GLASTAR SERVICE BULLETIN 39

Subject: Counterweight attachment to elevator counterweight ribs

Applicability: All GlaStar fuselage kits shipped prior to 12/8/98

Figure 1: Third Hole Location for Ribs
Already Drilled

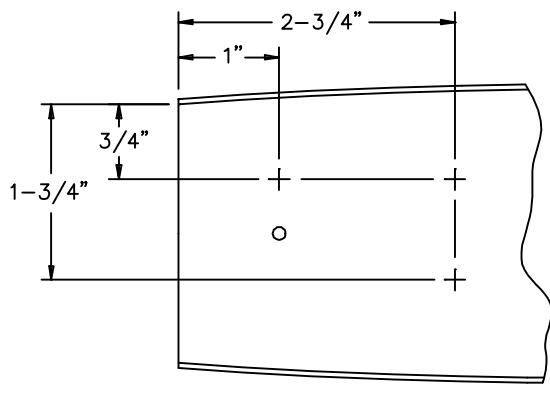
The cause of the observed cracking can likely be traced to the fact that the counterweight lead is attached with only two screws. These screws define a single axis about which the lead "rocks" when subjected to vibration in the course of normal operations. This fatigues the metal around the screw holes, allowing cracks to propagate. The solution is to add a third attach screw to prevent the rocking action of the counterweight.

Figure 1 shows the recommended location for installing a third attach screw through the counterweight stack for ribs that have already been drilled per the *Assembly Manual*. Figure 2 shows new recommended locations for all three holes for ribs that have not yet been drilled. Drill the appropriate hole(s) through the rib and the lead stack per the instructions for Step 39 in "SECTION V: ELEVATOR ASSEMBLY" and Step 174 in "SECTION X: FINAL ASSEMBLY."

Secure the counterweight stack with AN509-10R24 flush-head machine screws, AN970-3 large steel washers and AN364-1032A nylon self-locking nuts. Two of each of these pieces of hardware are supplied with this bulletin.

Note In drilling the third hole through an already completed counterweight stack, you are removing some mass from the counterweight. However, the difference between this lost mass and the mass added by the additional screw, washer and nut is entirely negligible. There is no need to rebalance the elevator after this procedure has been accomplished.
